**STATE OF HAWAII
DEPARTMENT OF TRANSPORTATION
AIRPORTS**

**ADDENDUM NO. 2
FOR
UST CLOSURE AND REPLACEMENT
ELLISON ONIZUKA KONA INTERNATIONAL AIRPORT AT KEAHOLE
KAILUA-KONA, HAWAII,
STATE PROJECT NO. AH2072-22R**

February 23, 2026

DETAIL MECHANICAL DEMOLITION PLAN

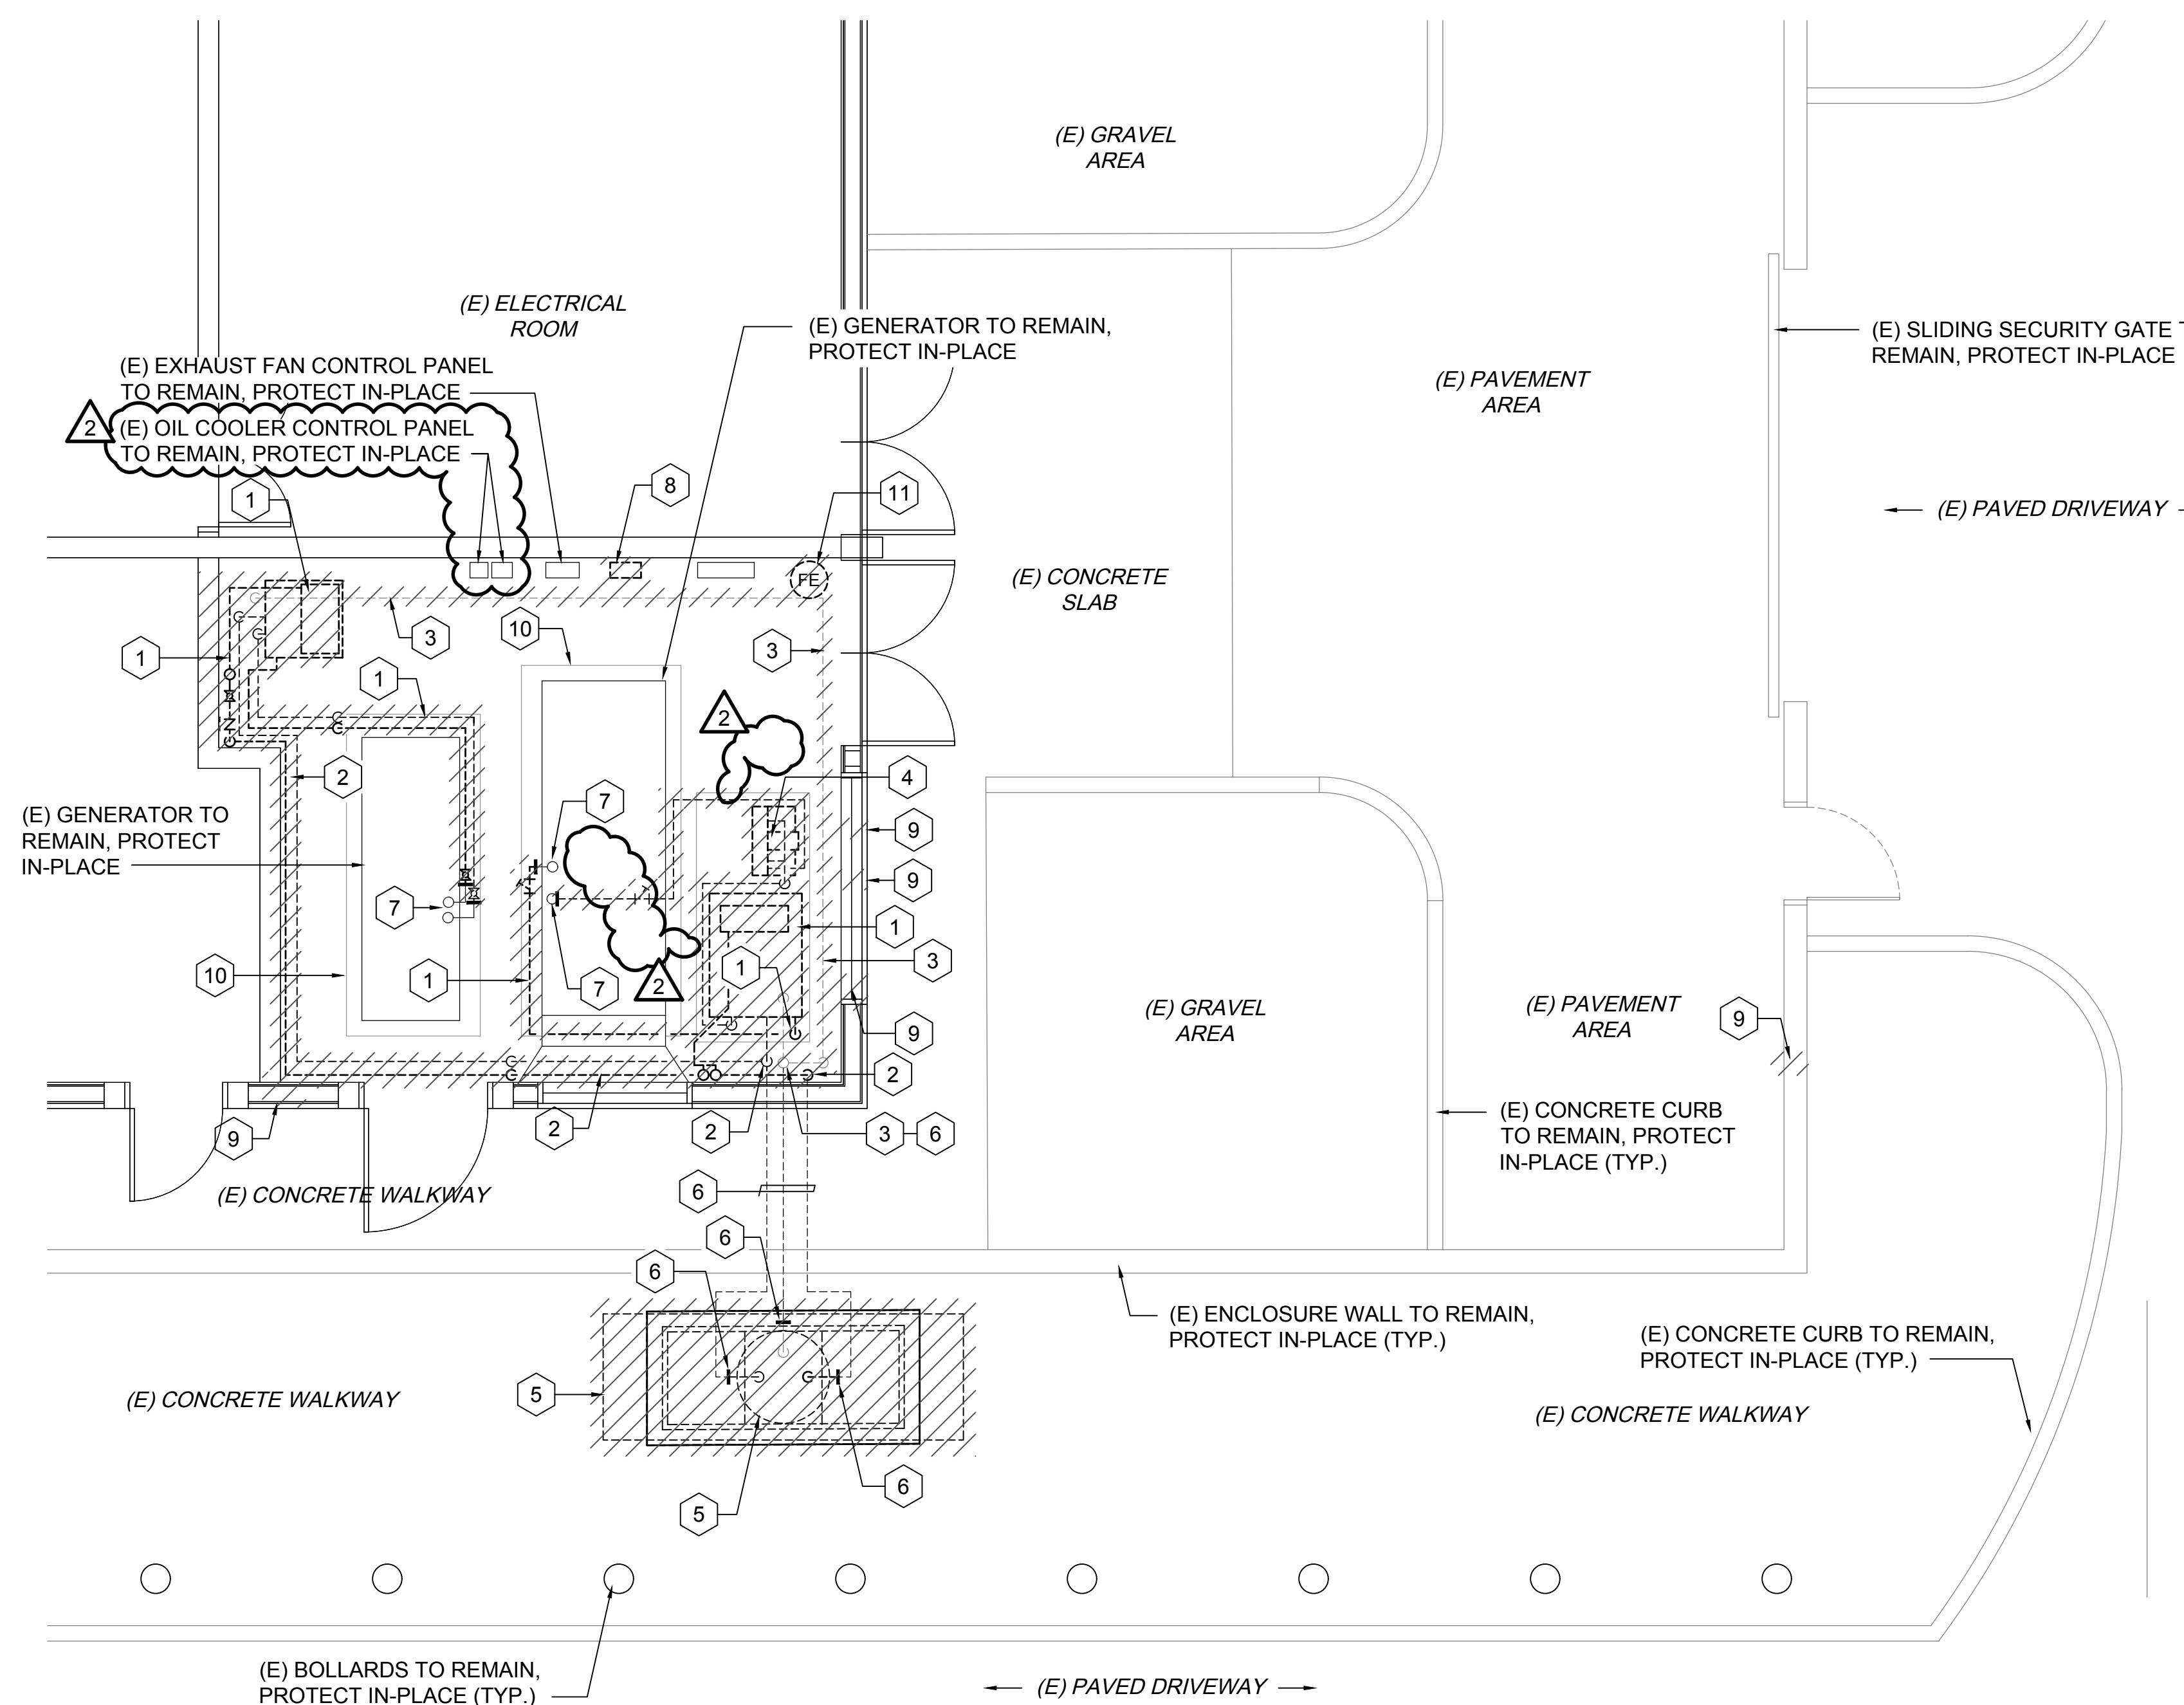
RESPONSE: Remove tank sump (reference Drawing No. M-101, DEMOLITION CALLOUTS #5).
